<b>IEEE 802.16 Broadband Wireless Access Working Group &lt;<a href="http://ieee802.org/16">http://ieee802.org/16</a>&gt;</b>	
Title	<b>MBS Security Support for PKMv2</b>
Date Submitted	<b>2004-06-24</b>
Source(s)	JUNHYUK SONG, Samsung <a href="mailto:junhyuk.song@SAMSUNG.COM">junhyuk.song@SAMSUNG.COM</a> David, Johnston, Intel <a href="mailto:dj.johnston@INTEL.COM">dj.johnston@INTEL.COM</a> Ypungman Park, Korea Telecom <a href="mailto:Youngman@kt.co.kr">Youngman@kt.co.kr</a>
Re:	Re: Security Adhoc PKMv2
Abstract	Proposal for MBS Security Support for PKMv2
Purpose	Discuss and Adopt as the baseline text
Notice	This document has been prepared to assist IEEE 802.16. It is offered as a basis for discussion and is not binding on the contributing individual(s) or organization(s). The material in this document is subject to change in form and content after further study. The contributor(s) reserve(s) the right to add, amend or withdraw material contained herein.

# PKM version 2

## MBS Security Baseline text proposal

## 2 Changes to 802.16e D3 text

Figure-xxx- MBS MAC PDU Ciphertext Payload Format

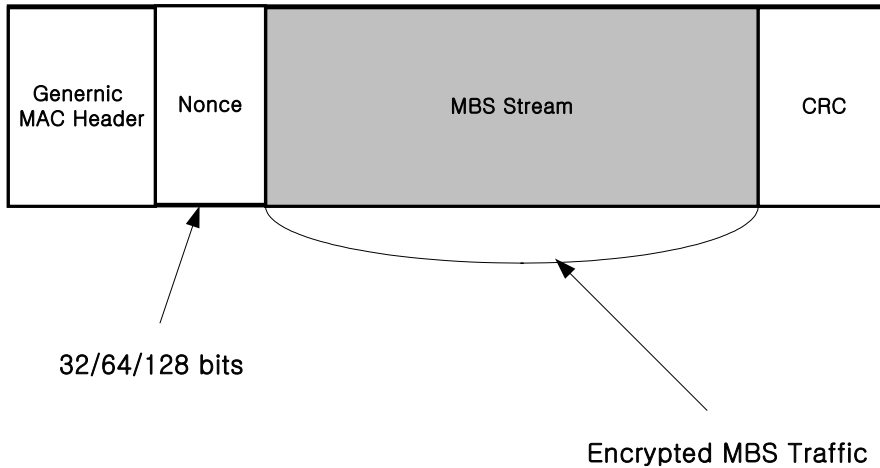
7.x.x.1.1 PDU Payload Format

The PDS payload shall be prepended with a 32/64/128 bits nonce randomly generated by base station. The nonce shall be transmitted in little endian byte order. The nonce shall not be encrypted.

The plaintext PDU shall be encrypted using the active MBS encryption key, according to CTR specification.

The processing yields a payload that is 32/64/128bits longer than the plaintext payload.
